HISTORIC AND DESIGN REVIEW COMMISSION

HDRC CASE NO: 2022-528
ADDRESS: 219 ADAMS ST
LEGAL DESCRIPTION: NCB 942 BLK 1 LOT 5
ZONING: RM-4, H
CITY COUNCIL DIST.: 1
DISTRICT: King William Historic District
APPLICANT: don fry/RIVER CITY LOANS INC
OWNER: don fry/RIVER CITY LOANS INC
TYPE OF WORK: Garage/ADU modifications, construction of a carport, gate
APPLICATION RECEIVED: October 12, 2022
60-DAY REVIEW: Not Applicable due to City Council Emergency Orders
CASE MANAGER: Jessica Anderson

The applicant requests a Certificate of Appropriateness to modify the existing garage, construct a carport, and add an electric driveway gate.

CUSTOM HOME
FRY CASITA

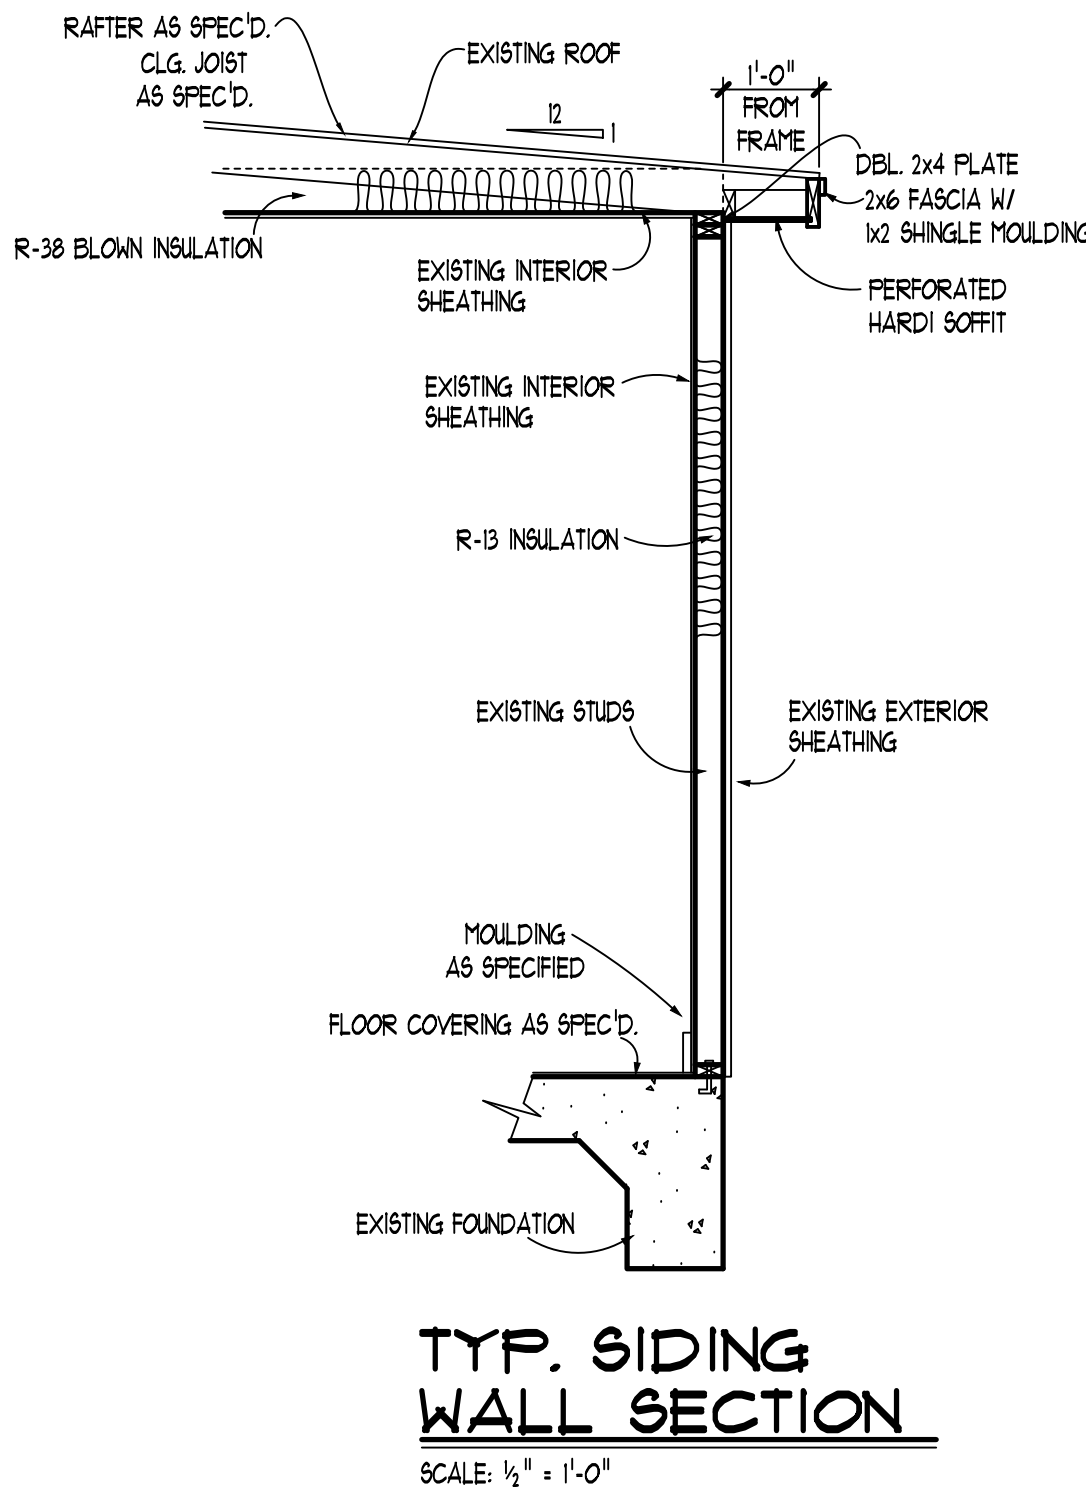
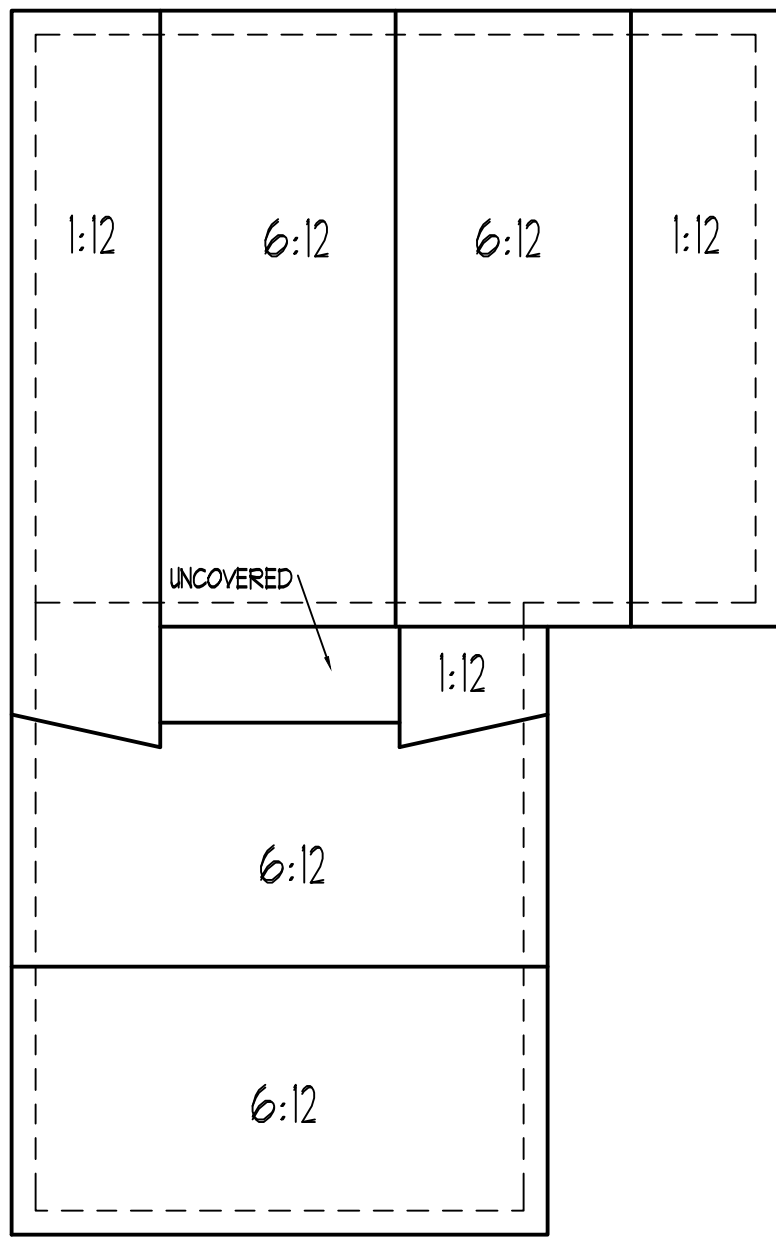
- b. **ACCESSORY STRUCTURE (MODIFICATION):** The applicant requests approval to modify the newly constructed garage by infilling the garage doors and modifying other fenestration to create an accessory dwelling. The roof form will remain the same, and windows and two doors salvaged from a demolished garage are proposed for restoration and installation. The south elevation, approved in 2020 without fenestration,

- c. **ACCESSORY STRUCTURE (WINDOWS AND DOORS):** The applicant proposes to reuse six one-over-one wood windows salvaged from the demolished detached garage and introduce five new windows. While this is generally appropriate, the applicant proposes new windows on the east and west elevations that differ in size from the salvaged windows. Staff finds that new windows should match the salvaged window in dimension and in materials. The applicant also proposes to salvage and reuse two doors (one wood fifteen-lite door and one wood half-lite door in a Craftsman style) and introduce one new door. The new door should be made of wood and match the style of one of the salvaged doors.

- i. That new windows match salvaged windows in dimension and materials.
- ii. That the new doors (including the replacement doors facing Wickes) be made of wood and match the style of one of the salvaged doors, namely either a wood fifteen-lite door or a wood half-lite Craftsman-style door.
- iii. That the applicant meets all setback standards as required by city zoning requirements, and obtains a variance from the Board of Adjustment if applicable.

The Apollo 12' Wide- 4' to 5' Single Drive Gate

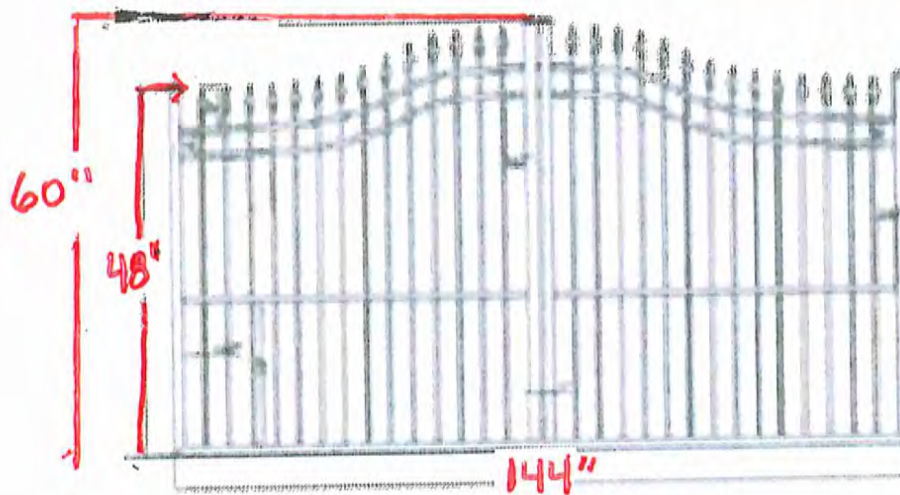
- e. **DRIVEWAY GATE:** The applicant requests approval to install a 5-foot-tall driveway gate on the north side of the parcel to intersect with the north elevation of the accessory structure. The Policy Guide for Fences in Historic Districts states that vehicle gates should be set behind the front façade wall plane. The proposed gate is behind the Wickes-facing façade of the detached accessory structure; staff finds this conforms to guidelines.

Staff recommends approval of the request to install a driveway gate based on finding e.
